Proposed
Amendments to the
Seton Ridge DA

Case 23746 & 22896

Feb 8, 2022

1. Case 23746: Amend Map 9Df of the Halifax MPS to remove a walkway to Bayview Road
2. Case 22896: Amend the DA to improve clarity for the developer moving forward.

Neighbourhood
Connectivity is Still
Excellent

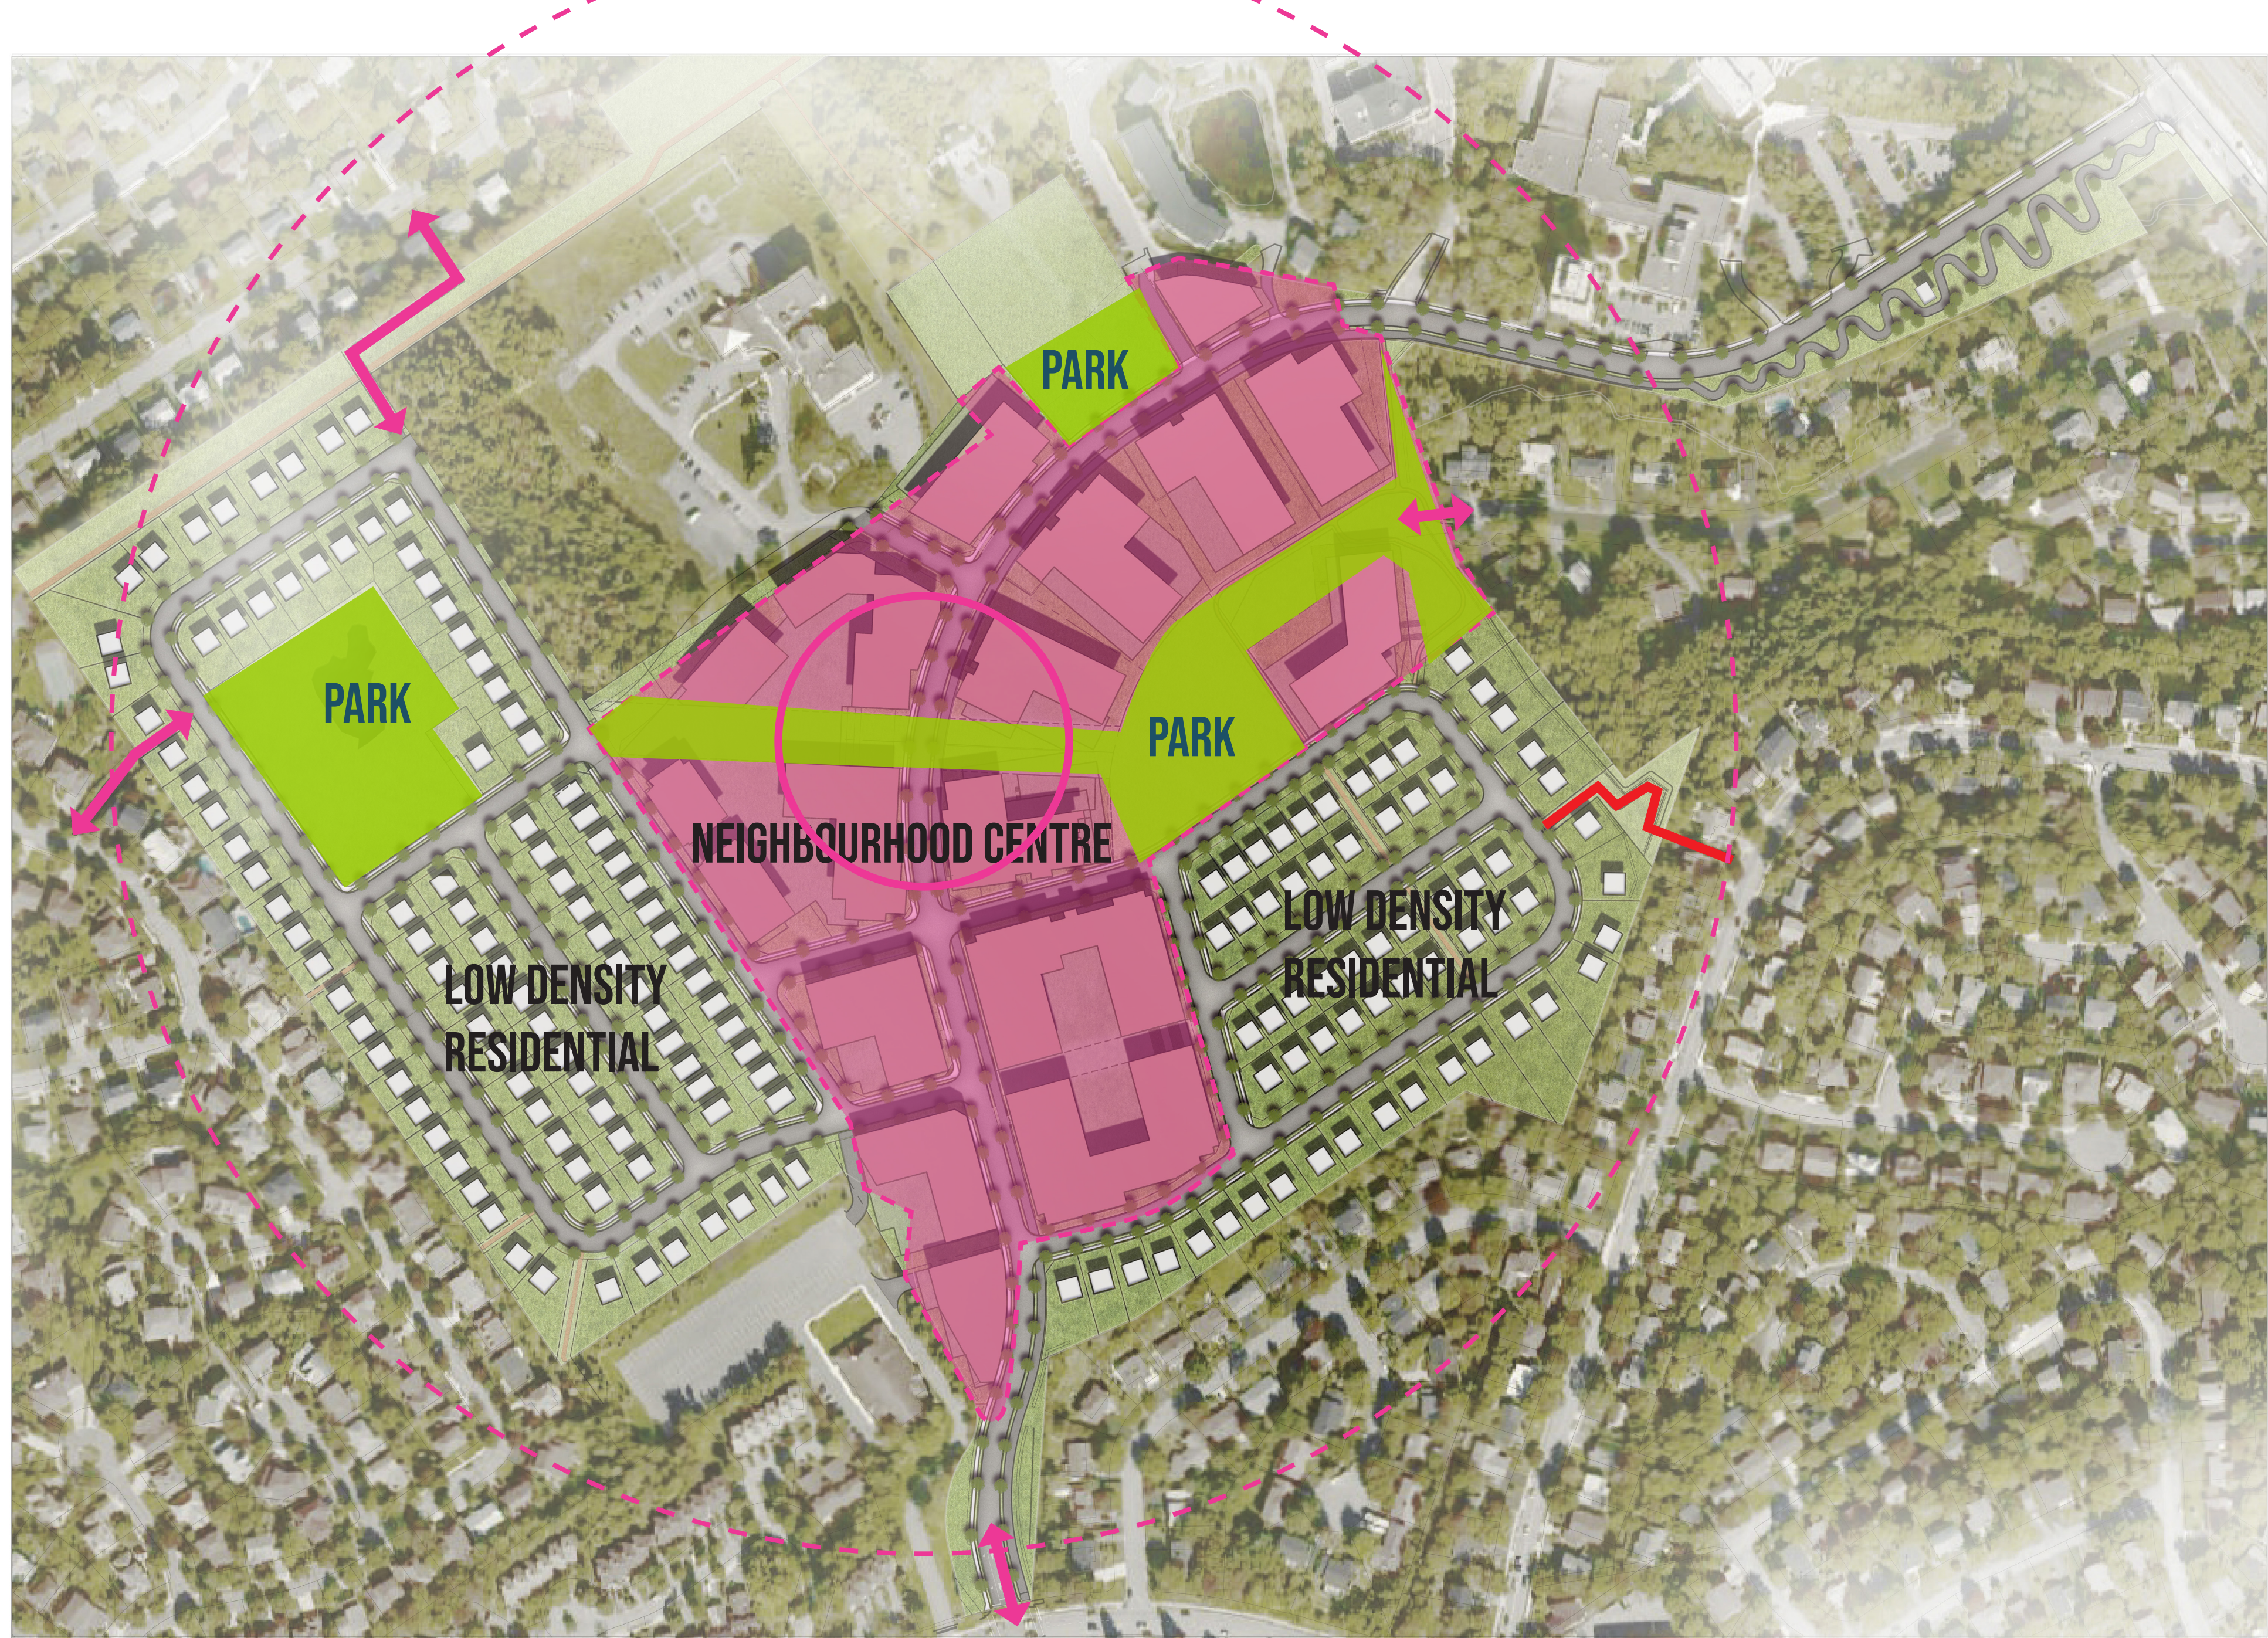
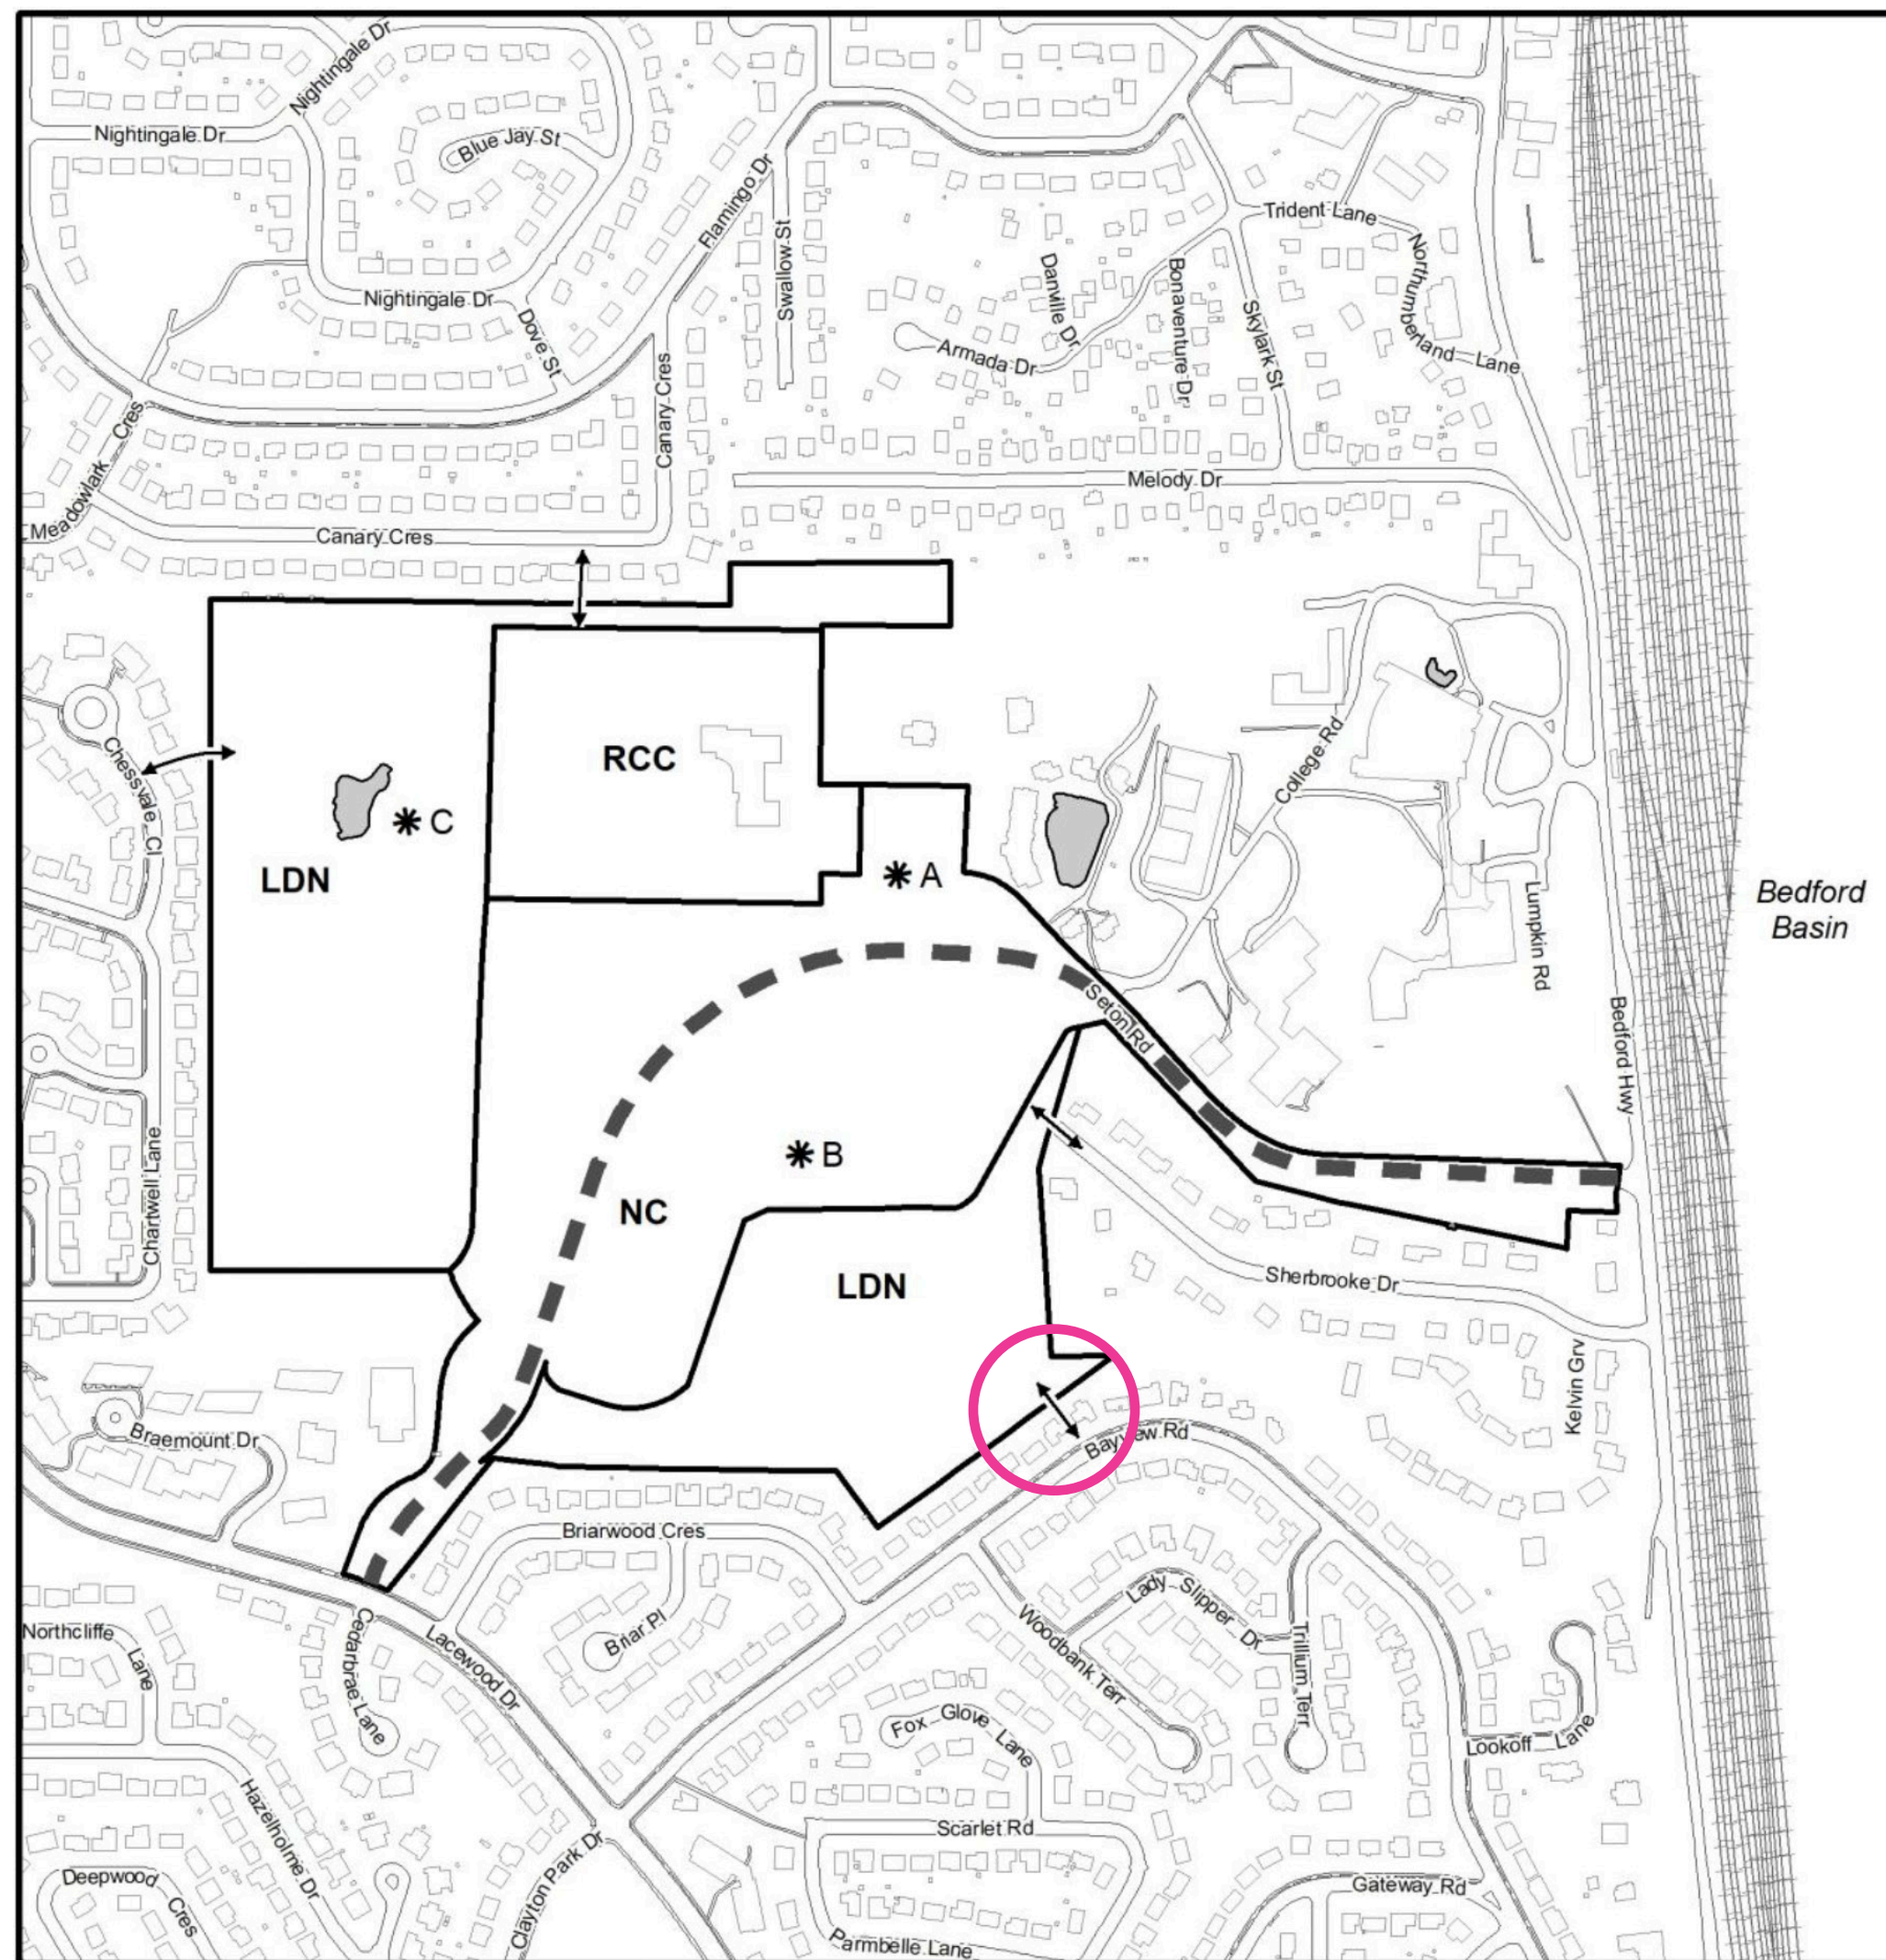
Worst case scenario
adds an extra 300m
of walking to get to
the core.

Rooftop Exemptions Table

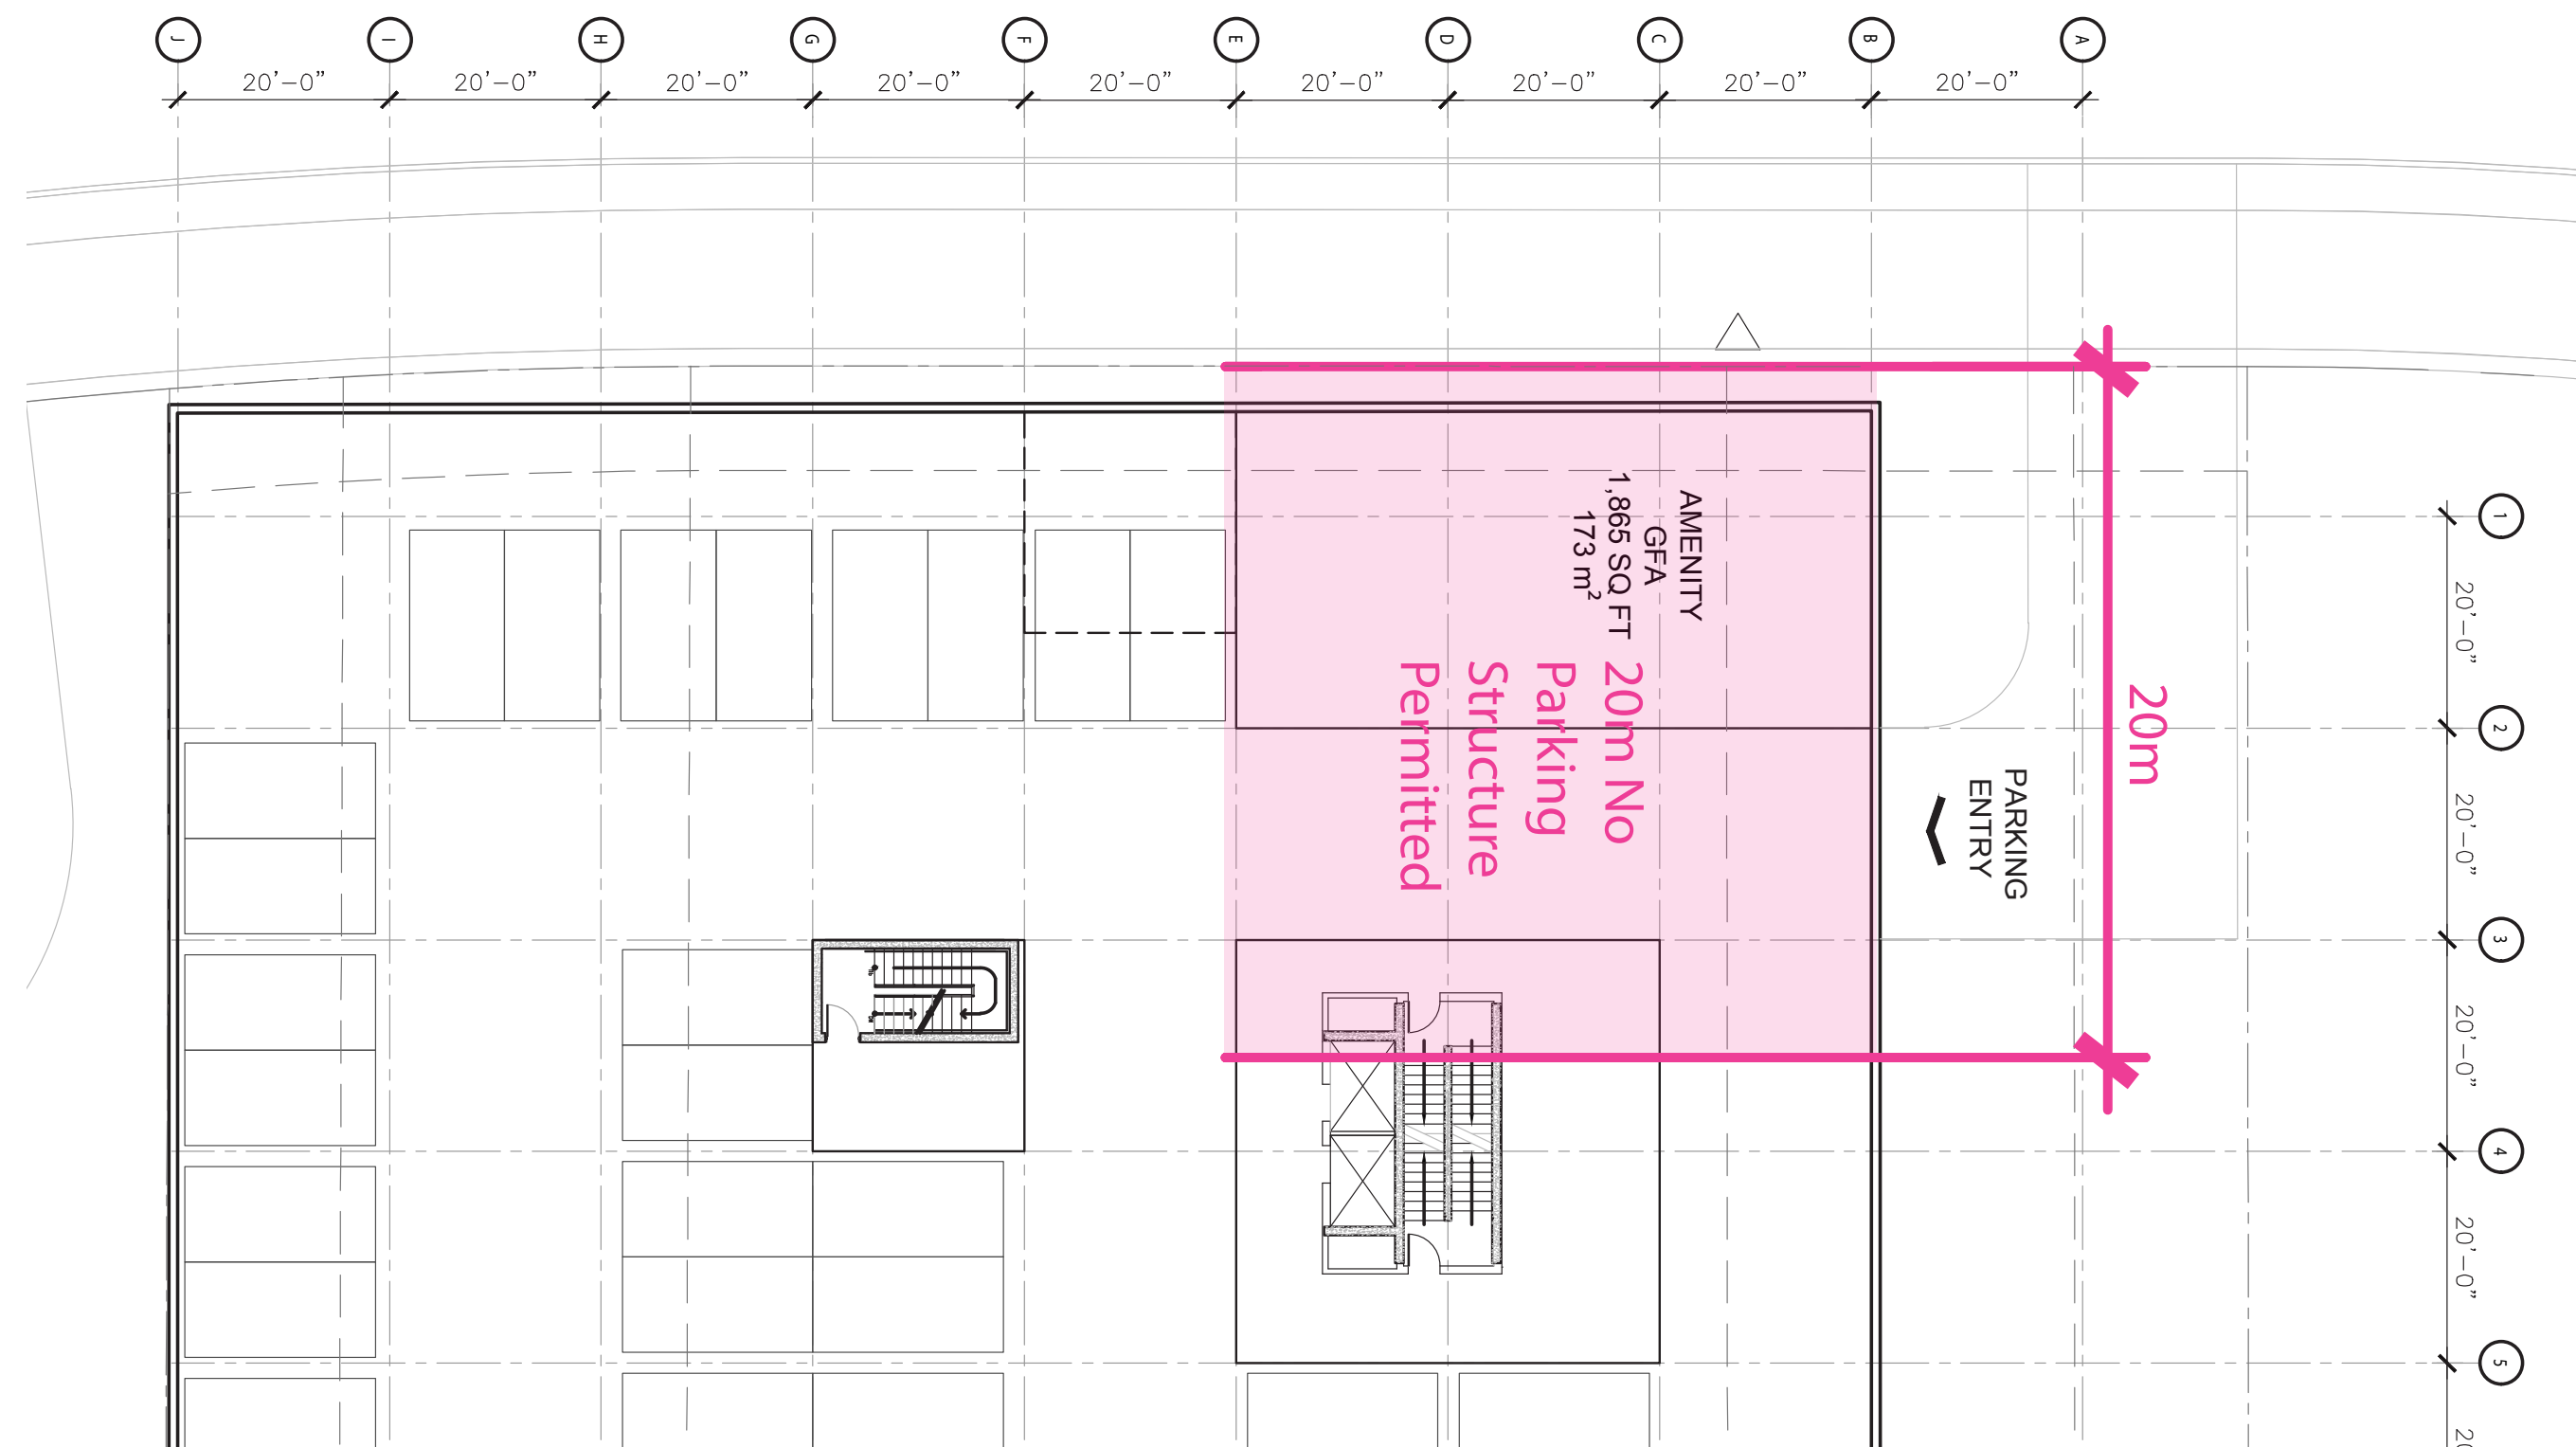
28A. Notwithstanding Section 28, the following rooftop features shall be permitted and shall be exempted from the calculation of “Height – NC Area”, subject to the requirements of the table below.
